STAFF RECOMMENDATION

2111 Early Avenue

July 21, 2021

Application: New Construction—Addition; Partial Demolition
District: Eastwood Neighborhood Conservation Zoning Overlay
Council District: 06
Base Zoning: R6
Map and Parcel Number: 08303009700
Applicant: Kaitlyn Smous, Nine12 Architects
Project Lead: Melissa Sajid, Melissa.sajid@nashville.gov

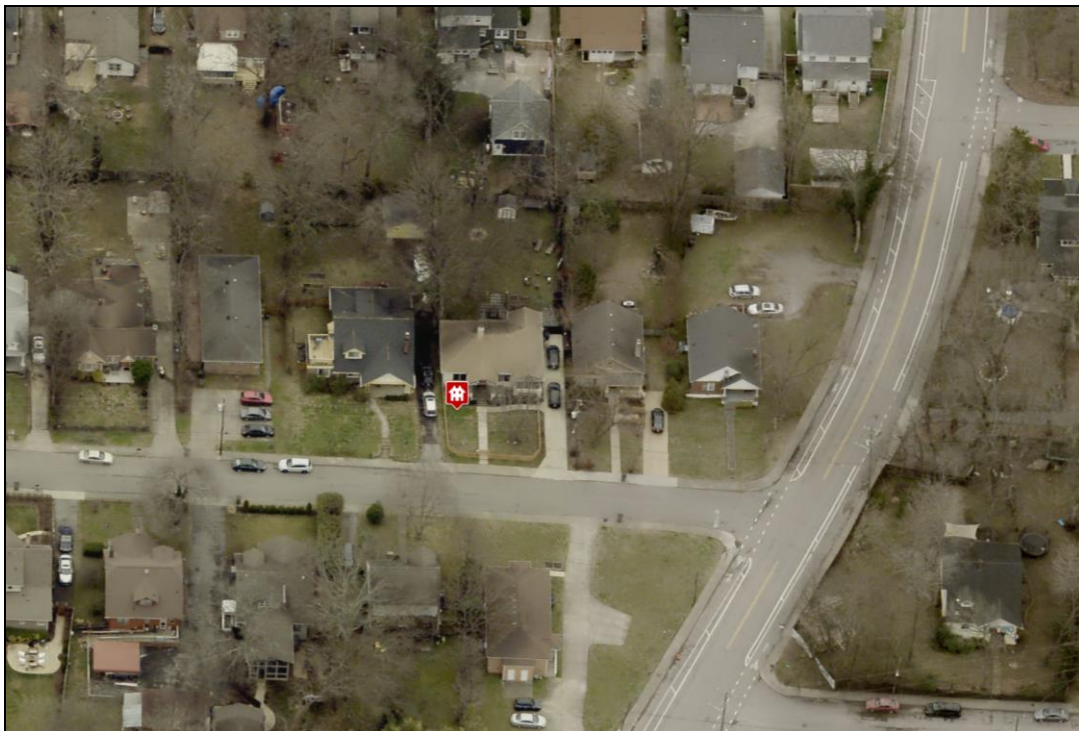
| <p>Description of Project: Application is to demolish an existing rear addition and to construct a new addition that extends four feet (4') taller than the historic house. No other changes to the historic house are proposed with this application.</p> <p>Recommendation Summary: Staff recommends disapproval of the project, finding that the addition does not meet Sections VI.A.1 (design), VI.B.2 (scale), VI.B.3 (scale), VI.B.5 (taller rear additions), VI.B.8 (height), and VI.B.9 (roof slope).</p> | <p>Attachments A: Site Plan C: Elevations</p> |

Figure 4. Proposed left-side elevation.

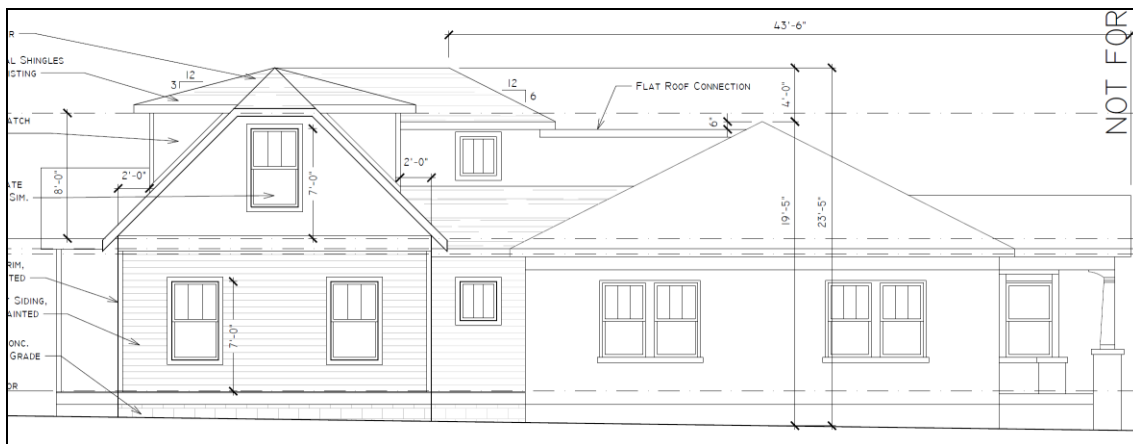
Roof Form: The addition has a complicated roof form (Figure 4). The primary form is a clipped side gable with a 6/12 pitch, but the addition ties into the hipped roof form of the historic house with a flat roof connection. The flat roof portion terminates below the eaves of a hipped roof portion that extends four feet (4') taller than the historic house. A front-facing dormer with a 3/12 pitch is located on the left-side elevation, and another dormer with the same roof form and pitch is incorporated on the rear façade of the addition.

While the roof forms and pitches could be appropriate for an addition, staff finds that the roof forms do not meet the design guidelines given that the addition extends taller than the two feet (2') of additional height that may be appropriate per the design guidelines. Therefore, staff finds that the project does not meet Section VI.B.9.
